AP-Ryefield Street, Peaks Island
(Assessor's 85-N-12)

Building permit to remove side wall (gable end) between living room and sun porch and replace with 4x12 header and to provide ceiling for existing sun porch at the above location is issued herewith but subject to the following conditions:

AP Ryefield Street,
Peaks Island-I
(Lot 85-M-12)--Mr. Paul Kelly

AP Eighth Maine Avenue,
Peaks Island-I
(Mr. Paul Kelly)

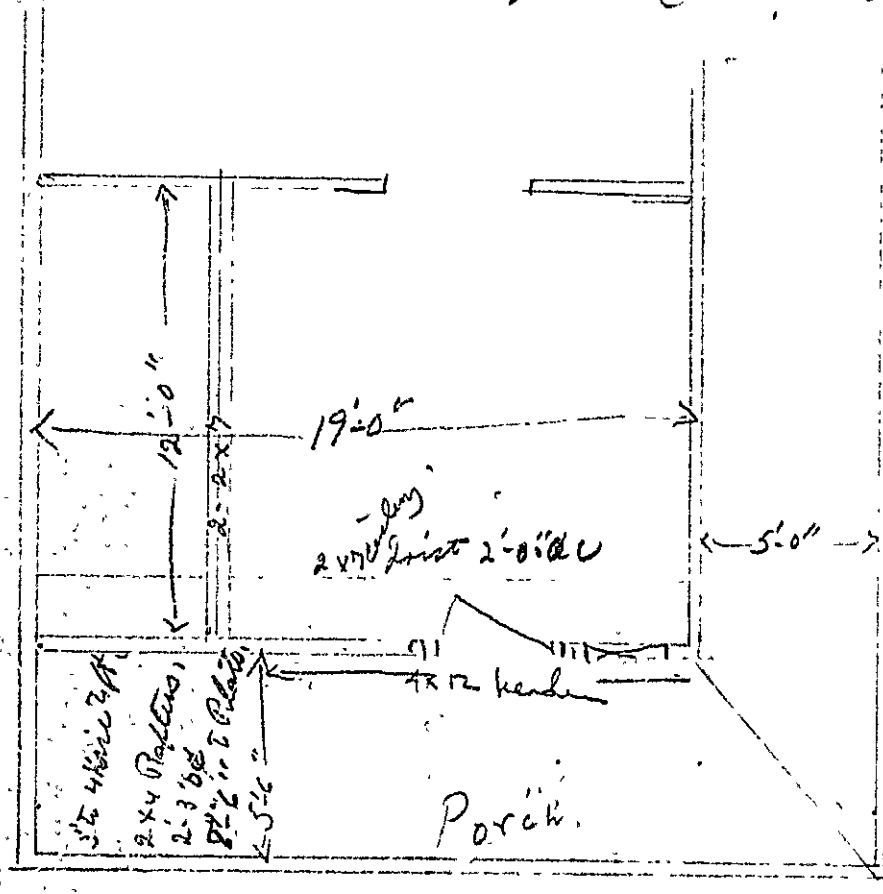
1. Unsupported length of 4x12 header is not to exceed 14 feet.
2. New 4x6 carrying beam approximately 6 feet long is to be provided under porch floor framing where presently omitted in line with existing 4x6 girder under main house parallel to Seashore Avenue.

PAUL KELLY'S HOUSE

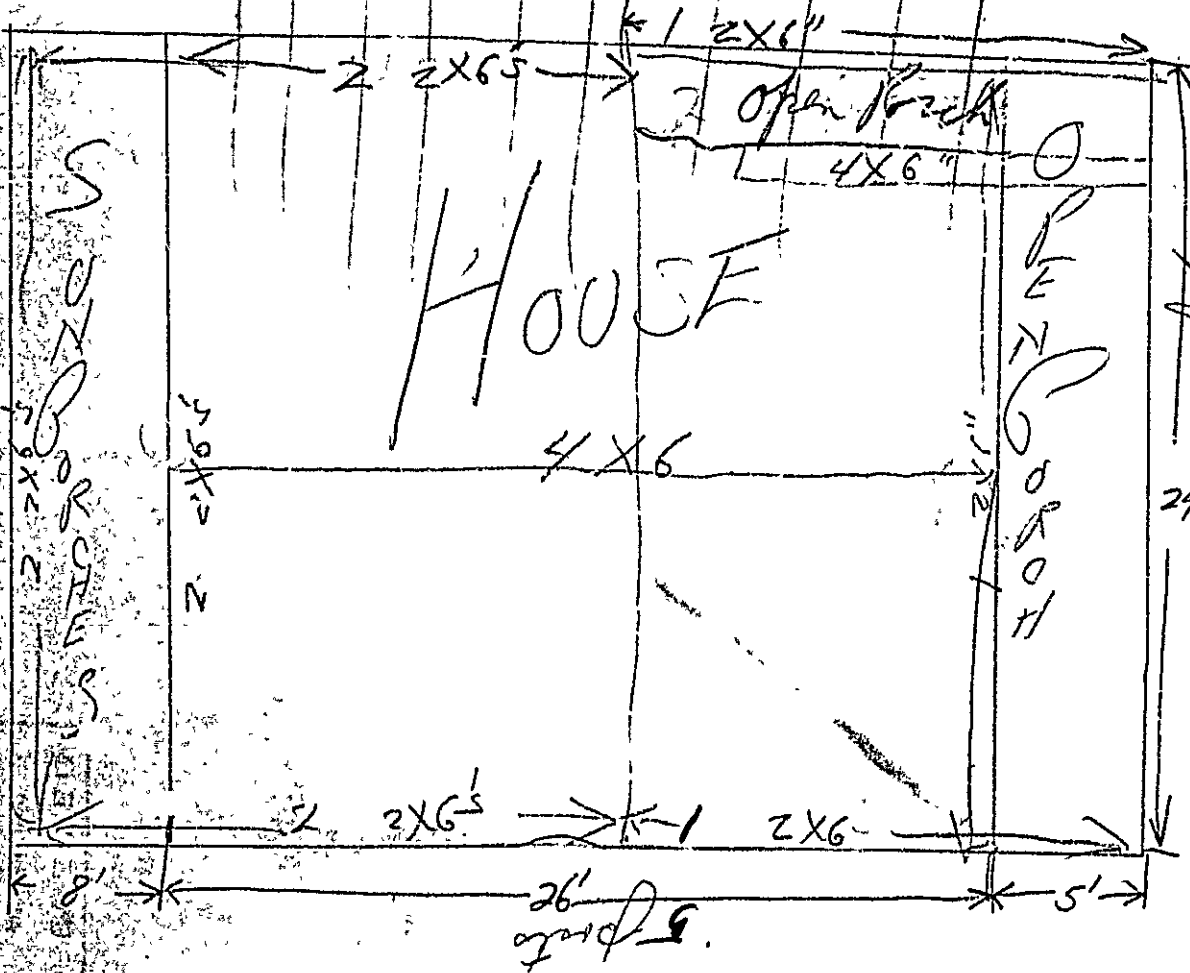
Member
 (A) At first floor ceiling is 2-1 1/2" x 6 3/4" on about 13' span. casis 2nd floor outside wall and roof. This does not figure out. If some support can be introduced or reduced this span or this member will work out. The above load of 24 #10 can be accepted otherwise the the floor joist span will be increased or it should permissible loading.
